Public Hearing Item 1: Variance Consideration

Board of Adjustment • September 10, 2025

File Number: 2025-007

Site Address: W6495 Kampen Rd

SITE PLAN

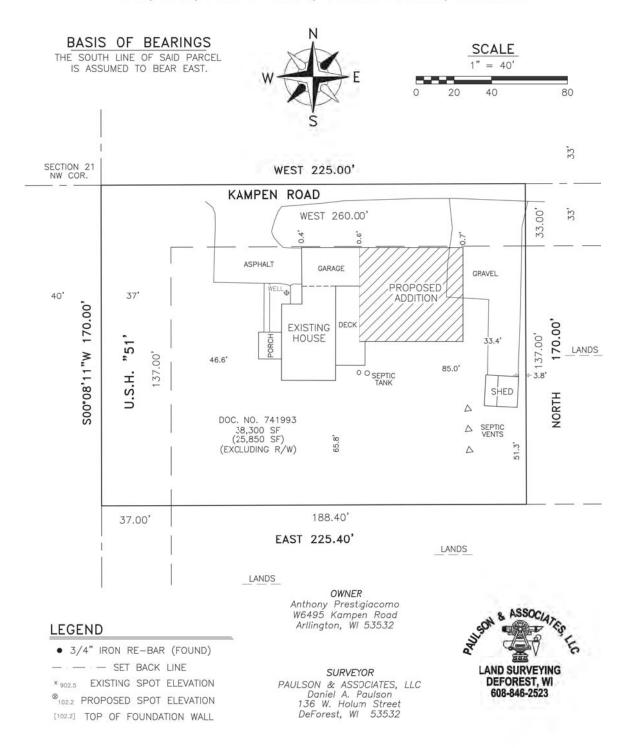
The property owner would like to place an addition onto the pre-existing single-family residence. The addition would be 50 ft. x 55 ft. x 32 ft. or 2,750 sq. ft. in size. This addition would be for an attached garage or storage space. Setbacks for the addition would be 33 ft. to the centerline of Kampen Rd., 0.6 ft. to the right of way of Kampen Rd., 88 ft. to the south rear property line, 36 ft. to the east side property line, 137 ft. to the centerline of

US Highway 51 and 100 ft. to the right of way of US Highway 51, over 10,000 ft. to the nearest navigable body of water, 1,361 ft. to the nearest wetland boundary, 15 ft. to the septic tank, and 34 ft. to the dispersal component. The addition would also be located in the visual clearance triangle of the intersection of US Highway 51 and Kampen Rd.

The property owner would like to place an addition onto the pre-existing single-family residence. The addition will meet the setback requirements to US Highway 51. Setback requirements for US Highway 51 are 110 ft. from the centerline of the road and 50 ft. to the right of way. Proposed setbacks for the addition to US Highway 51 are 137 ft. to the centerline and 100 ft. to the right of way. However, the property also fronts on Kampen Rd. The driveway is located on Kampen Rd., so this is treated as the front of the property. Required setbacks to Kampen Rd. are 63 ft. to the centerline and 30 ft. to the right of way. The addition is proposed to be 33 ft. from the centerline of Kampen Rd. and 0.6 ft. from the right of way.

Section 12.135.04(1)(c) allows for additions to nonconforming structures that are one half or more of any required setback. As the pre-existing single-family residence is not greater than one half of the required setback to Kampen Rd. and the addition is not proposed to meet required setbacks to Kampen Rd a variance to this section is required. Due to the location of the pre-existing single-family residence when constructed a variance would be required for any addition to the residence.

Kampen Rd. is a Town road that intersects with US Highway 51, which is a state or federal highway. When two such roads intersect a visual clearance triangle is created. A chord connecting said centerlines that is 200 ft. from the intersection of a state, federal, or county highway and a town road. There are to be no objects greater than two and one-half (2.5) ft. in height within this area. Open fences, telecommunication and power transmission poles, lines, portable equipment, field crops, and deciduous trees with mature canopies beginning greater than eight (8) ft. from the ground are exceptions to the rule. Approximately 1,362 sq. ft. of the addition will be located in this area (Exhibit I).

- 1. Development of the property shall be in compliance with the approved site plan, regarding locations and setbacks of proposed structures, as determined by Staff in Exhibits B, C, and K.
- 2. Construction can commence once all applicable permits from the State, County, and Town are obtained.
- 3. A foundation survey will be a requirement of the zoning permit.
- 4. The variance must be initiated by securing a zoning permit within one year of approval, failure to do so will render the variance void.
